**PLANNING COMMISSION  
Meeting Agenda  
Monday – March 22, 2010  
7:00 PM - Regular Meeting  
City Council Chambers – 155 NW 2<sup>nd</sup> Avenue**

## **STAFF REPORT**

MOD 10-01

CITY OF CANBY  
 SITE IMPROVEMENTS PLAN  
 WASTEWATER TREATMENT FACILITY IMPROVEMENTS  
 CLACKAMAS COUNTY, OREGON

1 UV DISINFECTION BLDG. NORTH ELEVATION  
SCALE: 1/2" = 1'-0"

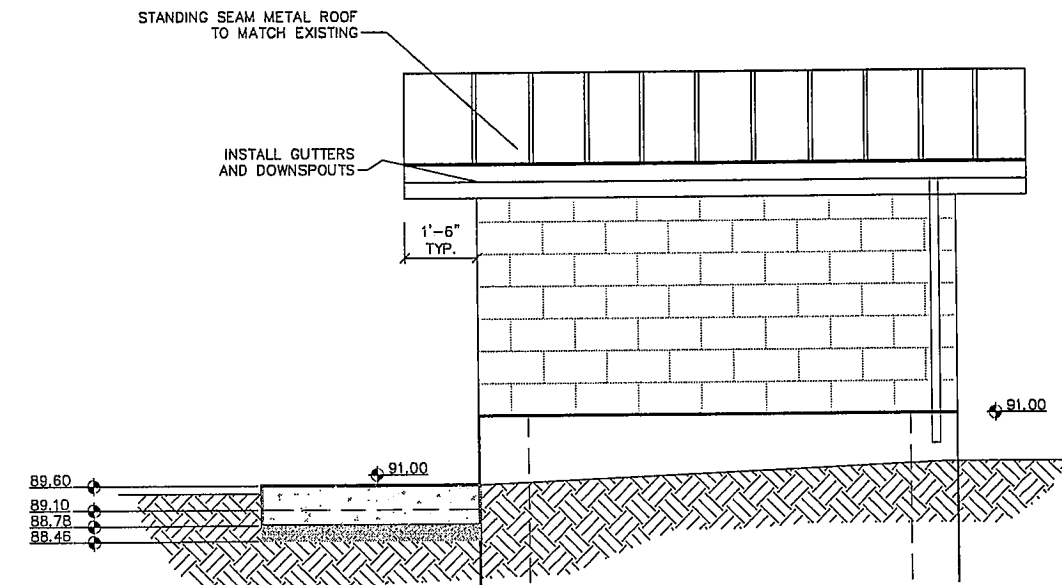
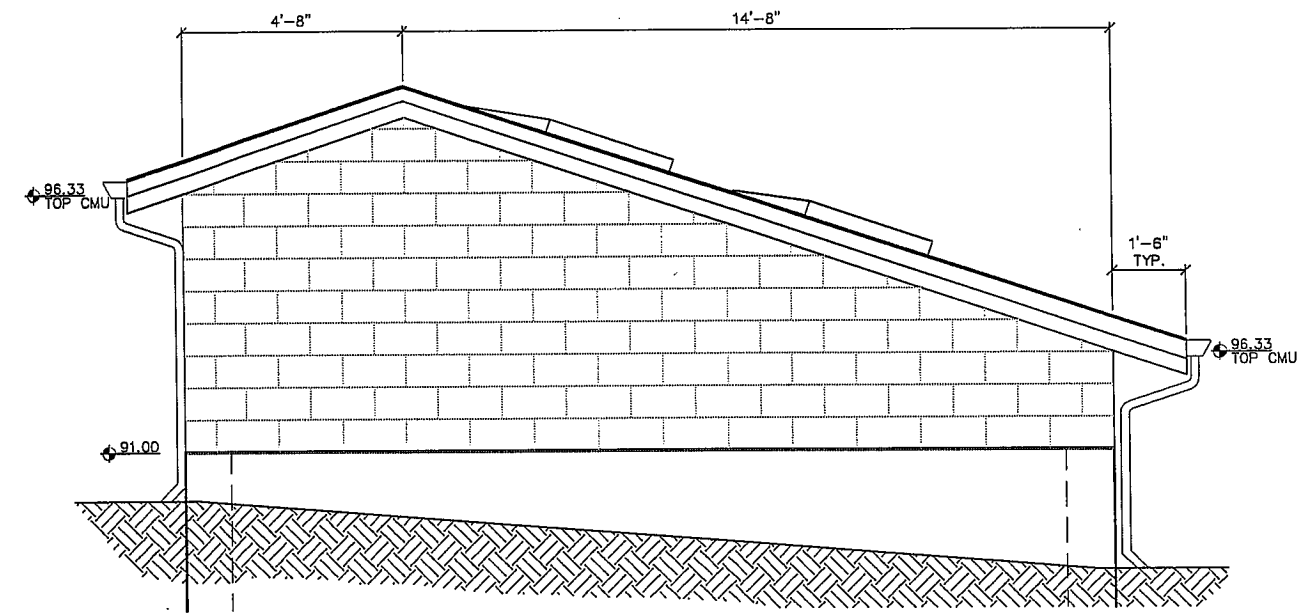
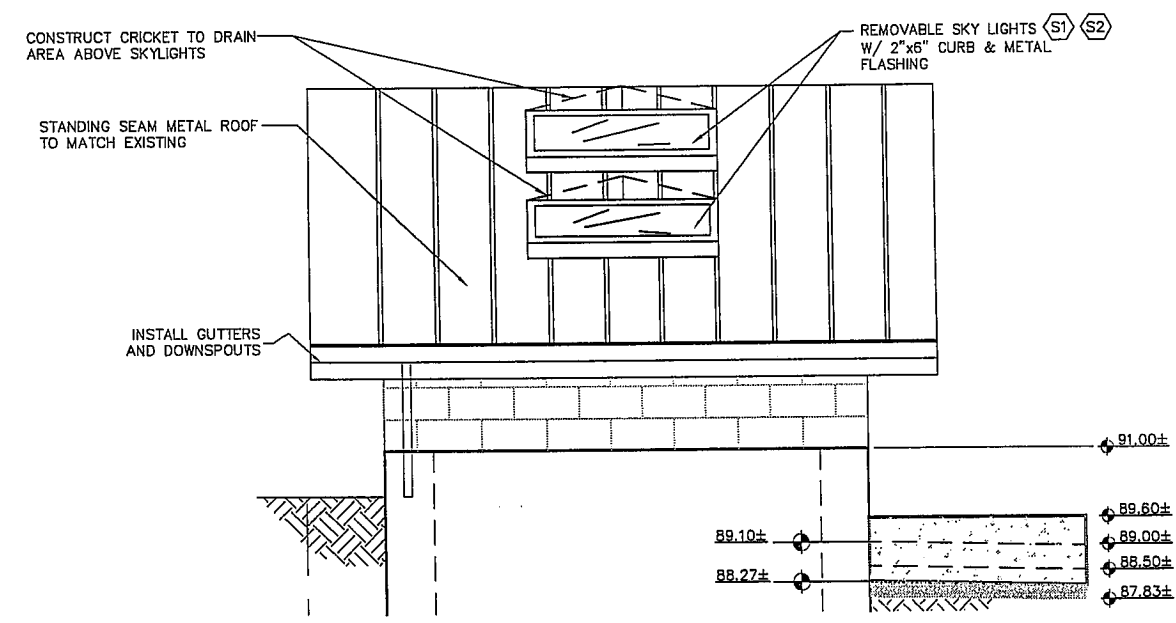
<b>Building Appearance</b>	
Style (architecture): not similar = 0; similar to surrounding = 1 or 2.	2 of 2
Analysis: The architecture of the new buildings, constructed of CMU and metal roofing, is similar to the existing buildings located on the site.

Color (subdued and similar is better): Neither = 0; similar or subdued = 1; similar and subdued = 2.	<b>2 of 2</b>
Analysis: Applicant has provided elevations, but has not provided a material sheet to determine what color the buildings might be. Therefore, in order to meet this criteria, approval shall include a condition that the color of the exterior walls of the buildings and roofing be a subdued color that is similar to the exterior treatments on the other buildings in the complex. With this condition, 2 points are awarded.	
Material: concrete or wood or brick is better.	<b>1 of 1</b>
Analysis: The applicant is proposing masonry exterior finishes; therefore 1 point is awarded.	
Size (smaller is better): over 20,000 sq ft = 0; under 20,000 sq ft = 1.	<b>1 of 1</b>
Analysis: The proposed buildings are both less than 20,000 square feet; therefore 1 point is awarded.

- The color of the exterior walls and roofing materials on the buildings shall be subdued and similar to the colors of other buildings on the site. Exterior of building shall meet this condition prior to the City issuing a final occupancy permit. (*condition #3*)

3. The color of the exterior walls and roofing materials on the buildings shall be subdued and similar to the colors of other buildings on the site. Exterior of building shall meet this condition prior to the City issuing a final occupancy permit.
